TX Optical Return Loss Tolerance and RX Reflectance Considerations (In support of comment #I-34)

Yi Tang, Cisco Mark Nowell, Cisco

IEEE P802.3db TF Ad Hoc meeting, 04/28/2022

Shift Margin Allocation from RX to TX

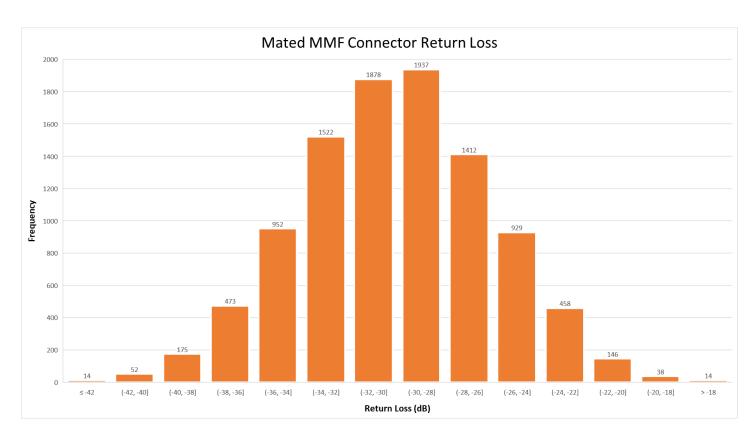
1.5dB TX ORL improvement by reducing RX reflectance from -12dB to -15dB with 3 connectors considered.

ORL at TX with RX Reflectance @ -12dB

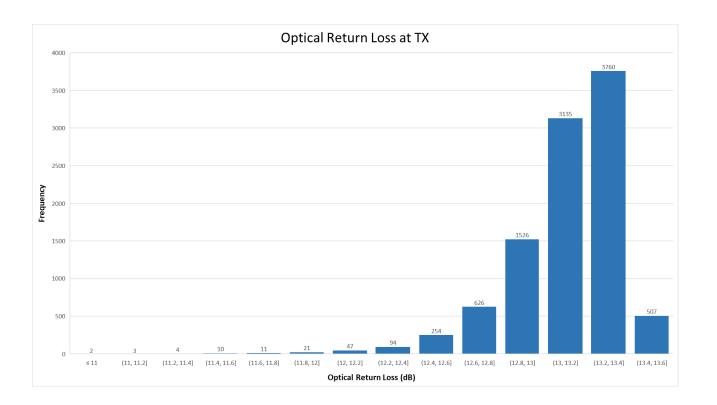
- Number of connectors: 4
- Transmittance per connector: -0.2dB

ORL @ TX (dB)	Frequency	Cumulative %
14	0	0.00%
13.8	0	0.00%
13.6	507	5.07%
13.4	3760	42.67%
13.2	3135	74.02%
13	1526	89.28%
12.8	626	95.54%
12.6	254	98.08%
12.4	94	99.02%
12.2	47	99.49%
12	21	99.70%
11.8	11	99.81%
11.6	10	99.91%
11.4	4	99.95%
11.2	3	99.98%
11	2	100.00%
	0	100.00%

ORL at TX with RX Reflectance @ -15dB

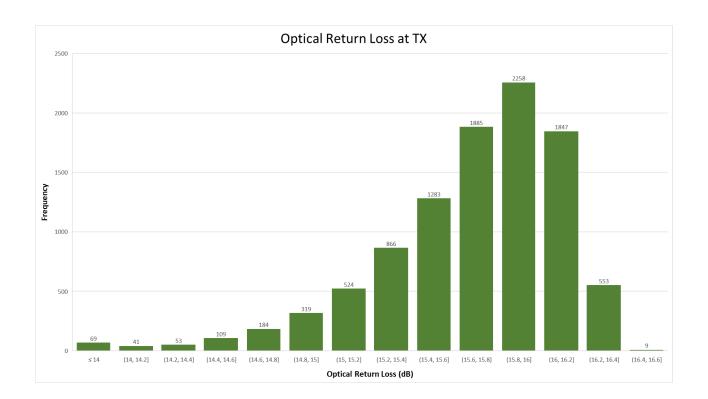
- Number of connectors: 4
- Transmittance per connector: -0.2dB

ORL @ TX (dB)	Frequency	Cumulative %
16.6	9	0.09%
16.4	553	5.62%
16.2	1847	24.09%
16	2258	46.67%
15.8	1885	65.52%
15.6	1283	78.35%
15.4	866	87.01%
15.2	524	92.25%
15	319	95.44%
14.8	184	97.28%
14.6	109	98.37%
14.4	53	98.90%
14.2	41	99.31%
14	69	100.00%
	0	100.00%

- Summary
 - The current RX reflectance requirement was leveraged from previous generation product/spec and based on glass-air interface assumption. -15dB reflectance can be achieved with minimum cost increase.
 - RX reflectance reduction can enable ORL tolerance margin for TX based on the existing model.
- Comment #I-34 proposes to
 - Change "Receiver Reflectance (max)" from -12dB to -15dB
 - Change transmitter "Optical Return Loss Tolerance (max)" to -15dB -> -14dB
 - Change transmitter spec "RIN₁₂OMA" to "RIN₁₅₁₄OMA"
